# Monthly Specification Update

**Intel® Server Board S5520UR**

*Intel Order Number E69054-001*

**October 2010**

**Figure 1. Removing the Heatsink**

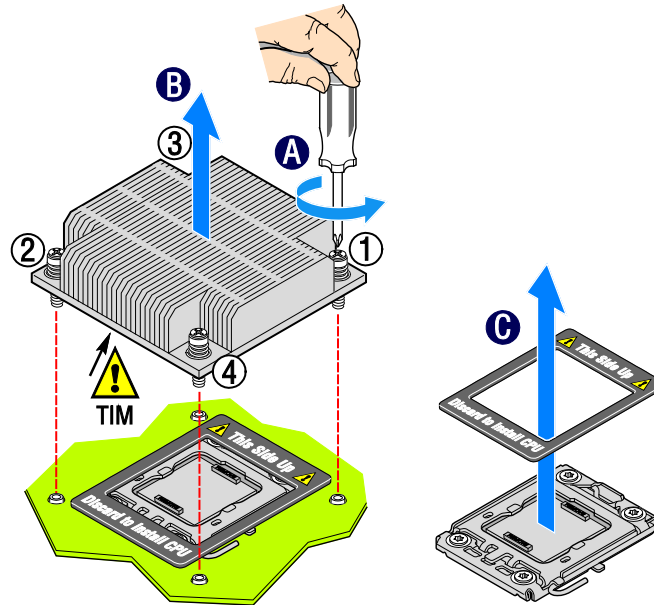
### 1. Proper Heatsink Installation and Removal Instructions are missing from Service Guide

**Problem:** The current documentation does not properly describe the installation and removal of the heatsink. Careful insertion and removal of the heatsink is required to prevent damage to the heatsink screws or backplate.

**Implication:** There is a possibility of damage to the heatsink if proper steps are not followed.

1. Loosen the four captive screws on the heatsink corners in a diagonal manner according to the numbers shown in figure 1 as follows:
  - Starting with the screw at location 1, loosen it by giving it **two rotations** in the anticlockwise direction and stop. (**IMPORTANT:** Do not fully loosen.)
  - Proceed to the screw at location 2 and loosen it by giving it two rotations and stop.
  - Loosen screws at locations 3 and 4 by giving each screw two rotations and then stop.
  - Repeat steps 1a through 1c by giving each screw two rotations each time until all screws are loosened.
2. Do one of the following:
  - If removing the heatsink for the first time, do the following:
    - i. Lift the heatsink from the board.
    - ii. Remove and discard the spacer (see letter “C” in figure 1).

- If a processor is already installed, do the following:
  - i. Twist the heatsink slightly to break the seal between the heatsink and the processor.
  - ii. Lift the heatsink from the processor. If it does not pull up easily, twist the heatsink again. Do not force the heatsink from the processor. Doing so could damage the processor.
